Canterbury Regional Council for
resource consents to take and use
water from the Waimakariri and
Rakaia Rivers and for all associated
consents required for the
construction and operation of the
Central Plains Water Enhancement
Scheme

**RESPONSE OF WALTER JAMES LEWTHWAITE
TO S42A OFFICERS' REPORTS
February 2008**

ECAN S42A OFFICER REPORT

**PLAN SHOWING LOCATION OF RAILWAY
LONG DROP**

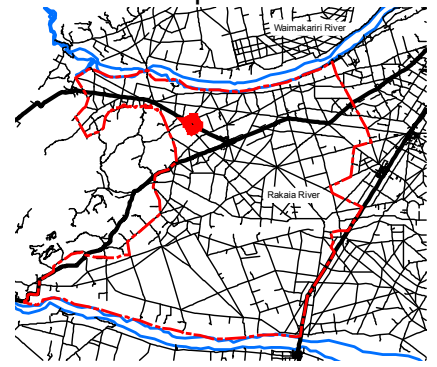
87. We have not been able to locate precisely the railway long drop other than knowing the property in which it is located (it is on SDC land) . We know that it is close to a proposed scheme race, and is possibly in the line of the race as shown at present. However it is clear there will be enough space in the property to avoid it by either re-routing the race by a small amount, or alternatively by piping the race at this point to reduce the width of construction. I attach a plan as Appendix 1 to show the location of the property.
